**SUBJECT: NINE MILE POINT NUCLEAR STATION, UNIT NO. 2 - CORRECTION LETTER  
TO AMENDMENT NO. 151 RE: MAXIMUM EXTENDED LOAD LINE LIMIT  
ANALYSIS PLUS (CAC NO. MF3056)**

### SAFETY EVALUATION

FOR MAXIMUM EXTENDED LOAD LINE LIMIT ANALYSIS PLUS MELLA+

NINE MILE POINT NUCLEAR STATION, UNIT 2

Figure-1. MELLLA+ Operating Domain for NMP2

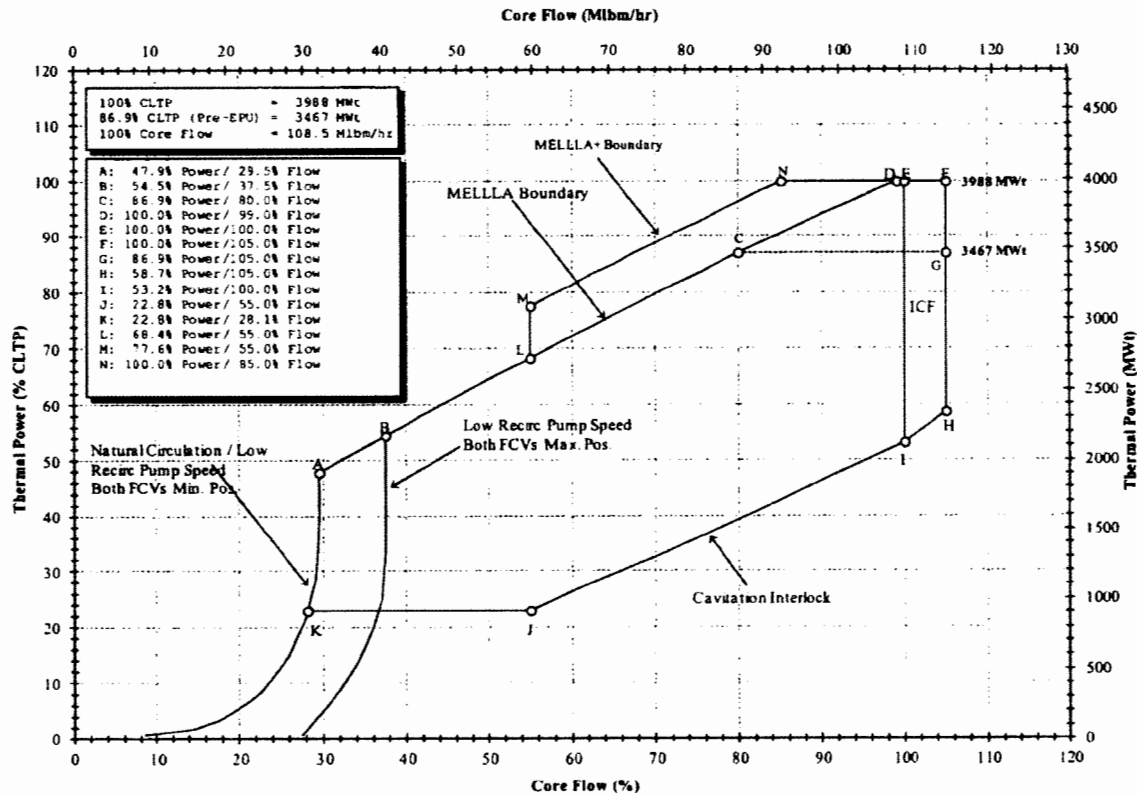
Table 1-1 of the SAR list all the computer codes used. Figure 1-1 of the NMP2 SAR reproduced here as Figure-1 defines the MELLLA+ operating domain. [[

Figure-2. Illustration of P/F ratio requirements from Limitation 9.3

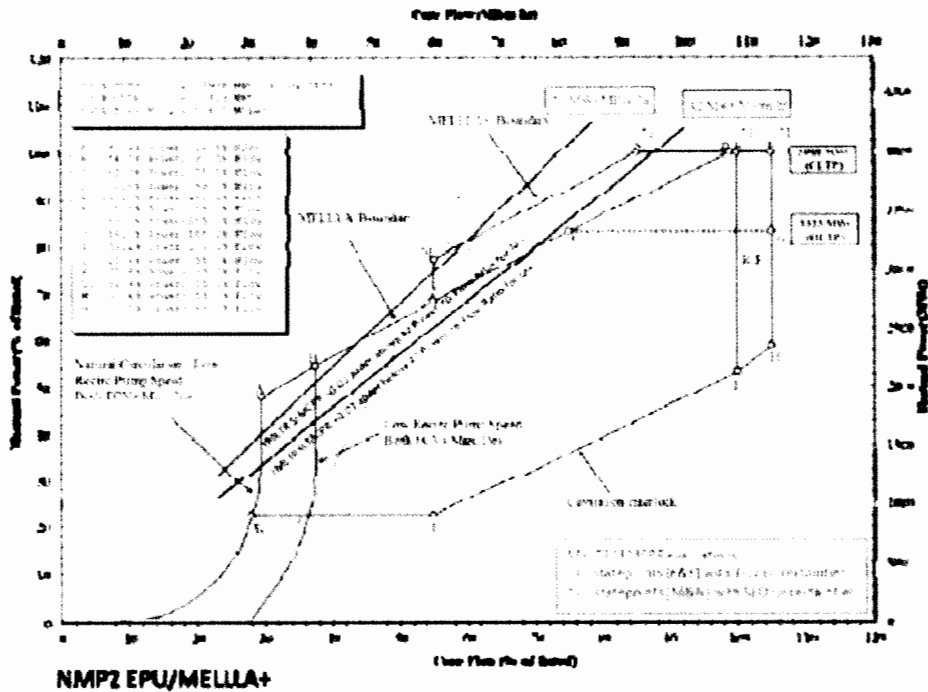
For operation at P/F ratio greater than 50 (for example, at point M in Figure-2), the staff SER required a case-specific evaluation to ensure that the particular plant is not an outlier and has unusual uncertainty values. The staff also required an additional penalty on the SLMCPR by using SLO uncertainties even though SLO operation is not allowed under MELLLA+. This restriction applies to the region in Figure-2 above the 50 MW/Mlbm/hr line, which is a very small area around point M. The staff reviewed on a plant-specific basis the power distribution uncertainties for NMP2. This review was based on a comparison of TIP data provided by the licensee against PANACEA calculated power distributions.

In addition to the 42 and 50 P/F lines (red lines), Figure-2 shows the line in the P/F map where the exit void fraction in the bypass region is supposed to be <5% (orange line) based on conservative ISCOR calculations. Bypass void fractions can affect the calibration of LPRM or TIP detectors because they are typically calibrated at full power where there is no bypass flow. The MELLLA+ SER requires that the bypass void fraction be lower than 5% to prevent this de-calibration issue. The calculation shown in Figure-2 confirms that bypass voiding is only a potential problem in NMP2 in a small area around point M (55% flow); however: (1) the void fraction is not higher than 5% at the LPRM location because it is lower than the TIP exit, and (2) NMP2 has committed (Division of Safety Systems, Reactor Systems Branch (SRXB) (2) RAI-1 response dated March 10, 2014), to avoid taking TIP measurements around point M. Therefore, the staff concludes that bypass voiding is not an issue for NMP2 operation in the MELLLA+ domain.

Figure-3. Location in power to flow map of available TIP data in Nine Mile Point 2

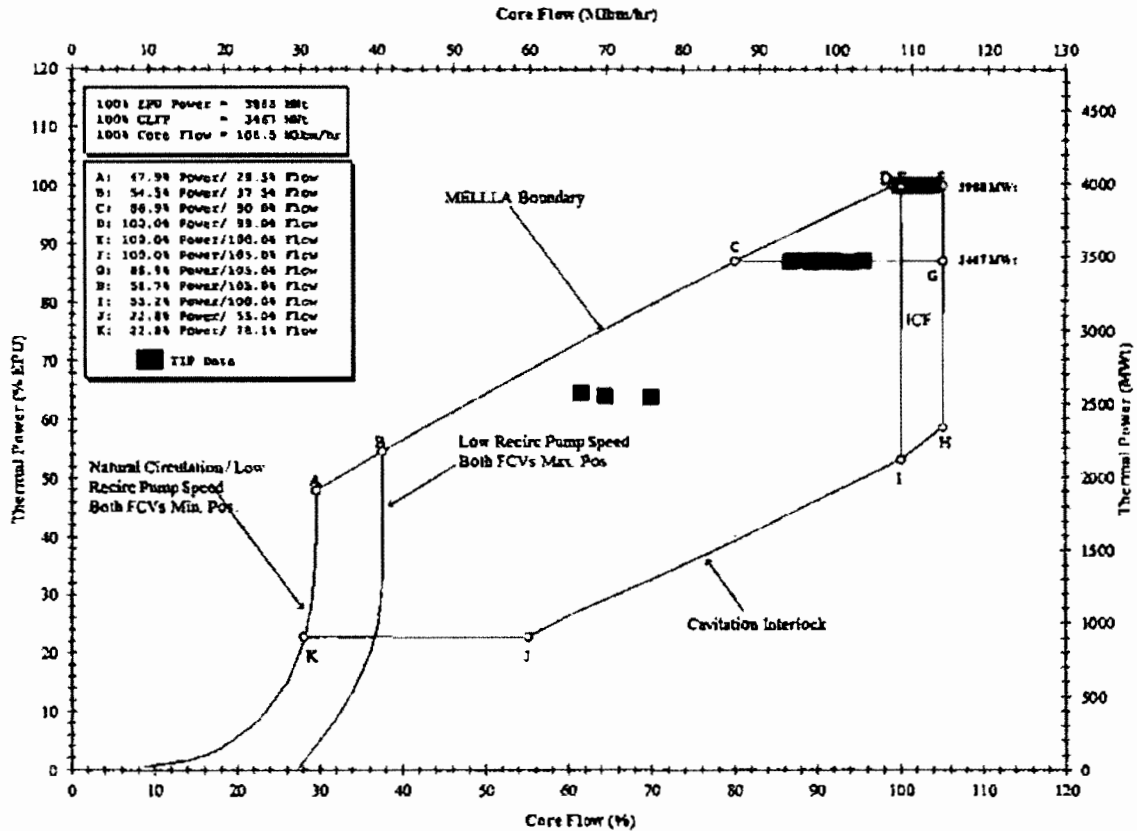
Following the guidelines from Methods Limitation 9.3, the staff has reviewed on a plant-specific basis the power distribution uncertainties for NMP2. This review was based on a comparison of TIP data provided by the licensee against PANACEA calculated power distributions. The TIP data encompasses three cycles from 5/2010 through 7/2014. Figure-3 shows the locations in the P/F map where TIP measurements were performed in NMP2 for the last three cycles (13-15). Analyses of these data show that the power distribution RMS error is between 3% and 7%, depending on the type of uncertainty. A more complete evaluation of the data is provided in Appendix A, RAI-1 evaluation of this SE. The TIP data was provided in the RAI-1 response.
